Public Service
Electric and Gas
Company

February 12, 1985

SIGNIFICANT CONSTRUCTION DEFICIENCY
EDG FUEL PUMP VALVE HOLDER
HOPE CREEK GENERATING STATION

FUEL INJECTION PUMP ASSEMBLY

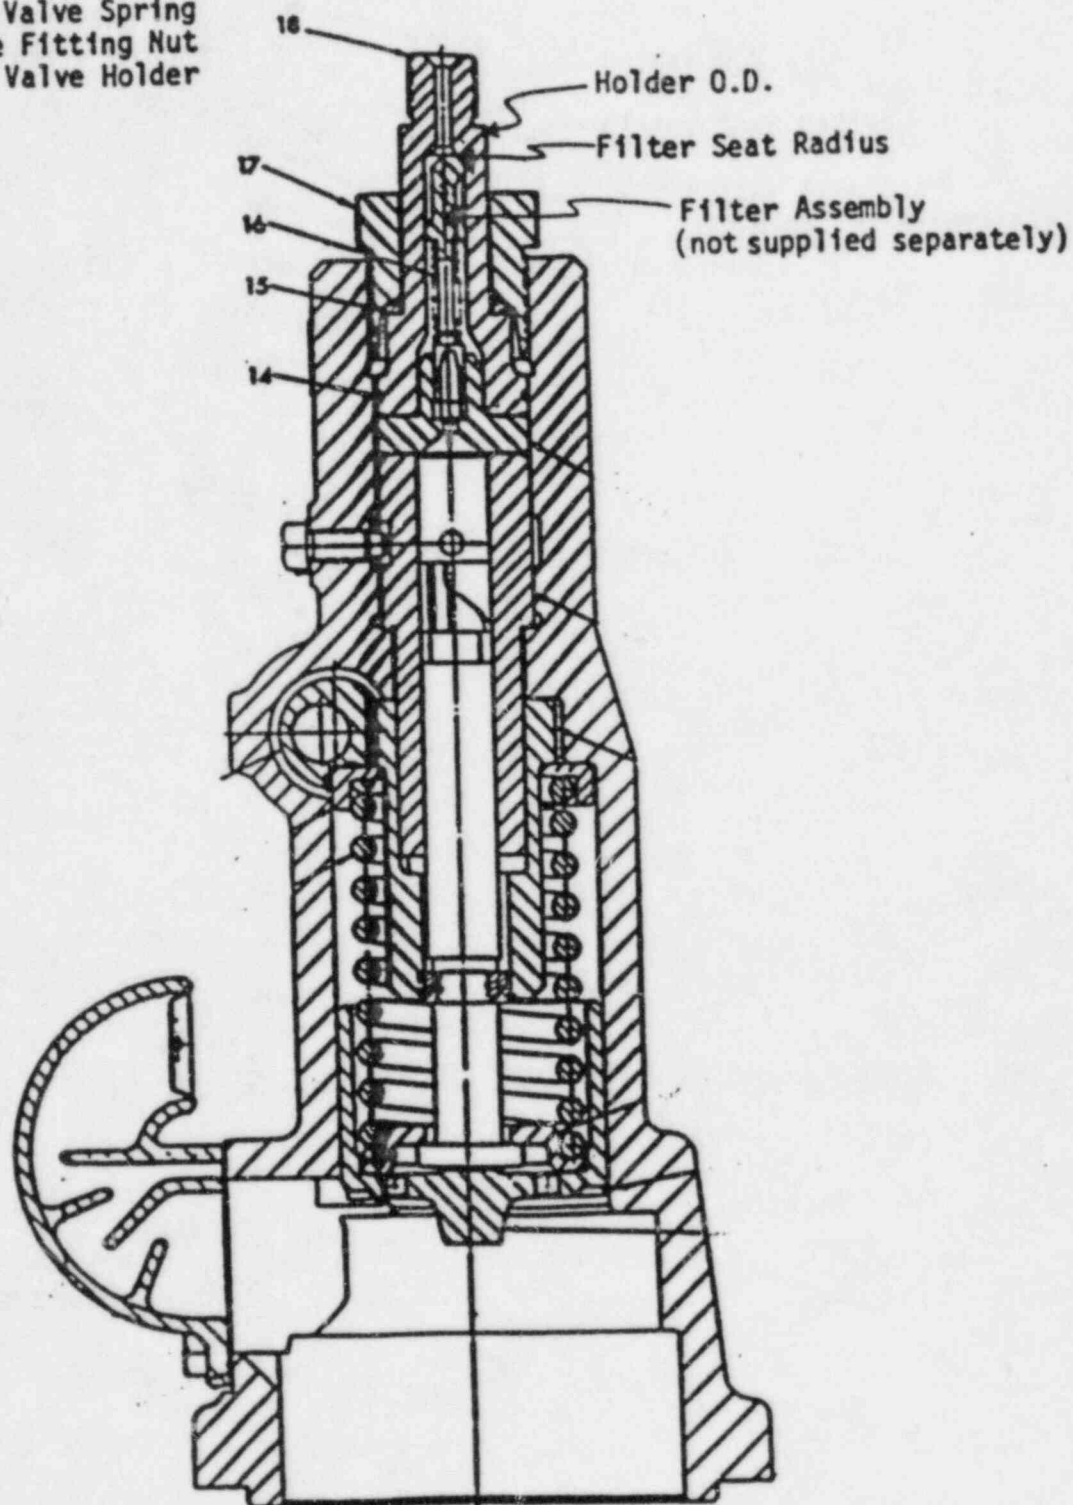
Colt Industries has advised our Architect/Engineer and Constructor, Bechtel, of a possible defect in the fuel injection pump delivery valve holders on our Emergency Diesel Generators. Colt states that a fatigue crack can occur at the filter seat radius (shown on attachment) and progress to the holder O.D. The crack results from an insufficient radius at the filter seat, causing a stress riser at this point. This may result in leakage of fuel oil under high pressure during the injection stroke.

In accordance with instructions received from Colt Industries, Bechtel will replace all forty-eight (48) of the affected components with acceptable replacements provided by the manufacturer. This activity will be witnessed and documented by Bechtel Quality Control personnel.
